PRODUCT/PROCESS CHANGE NOTICE (PCN)

PCN #: **TB0605-05** DATE: **7/01/06**

Product Affected: **CVBGA 52L & 56L Products**
shipped in tray

Existing Shipping Tray

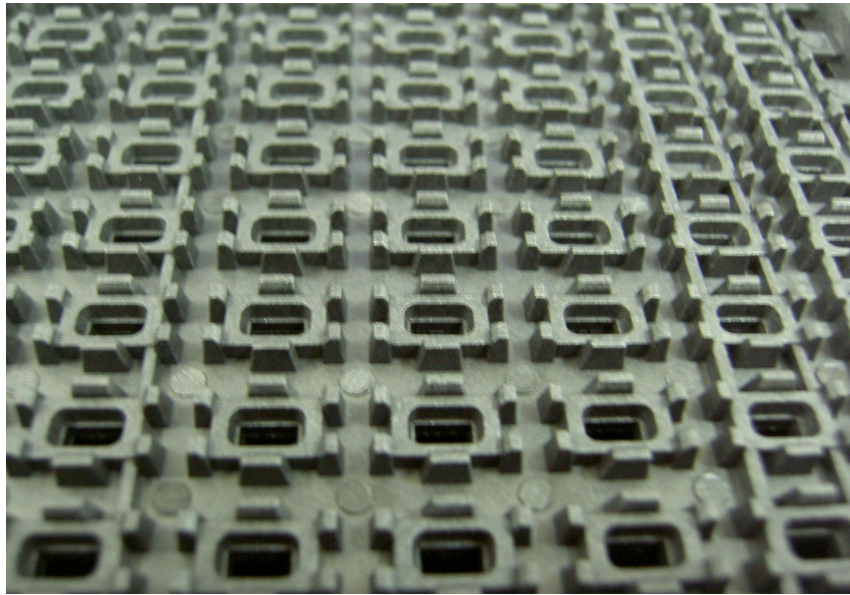
Please note that there will be a change in number of units per tray from 325 to 364 units/tray. There is no change in the tray dimensions.

| Description | Existing Shipping Tray | New Shipping Tray |
|-------------------|------------------------|----------------------|
| Pocket Size (WxL) | 4.67x7.17 +/- 0.08mm | 4.64x7.14 +/- 0.08mm |

New Shipping Tray

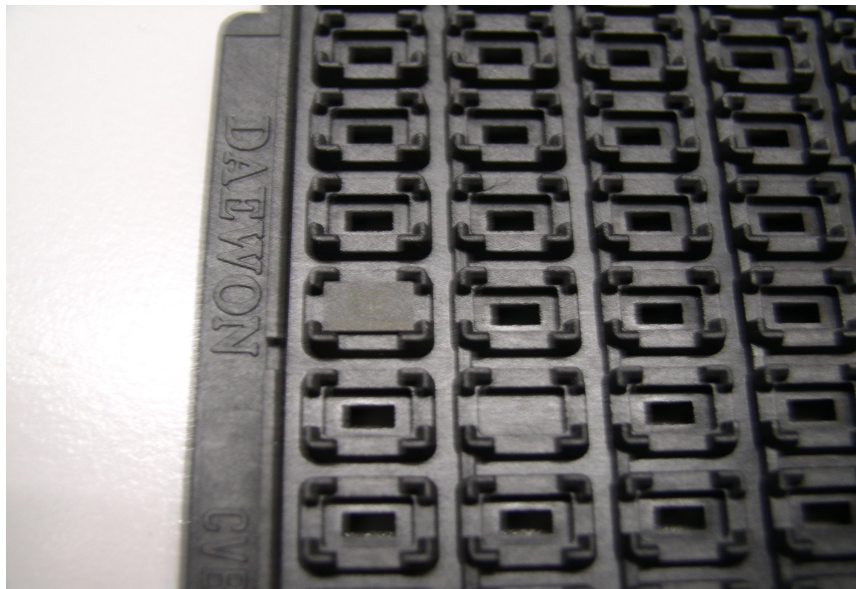
Detail of Change: This notification is to advise our customer that IDT has qualified new shipping trays for CVBGA 52L and 56L products. The new trays provide better protection during product shipment.
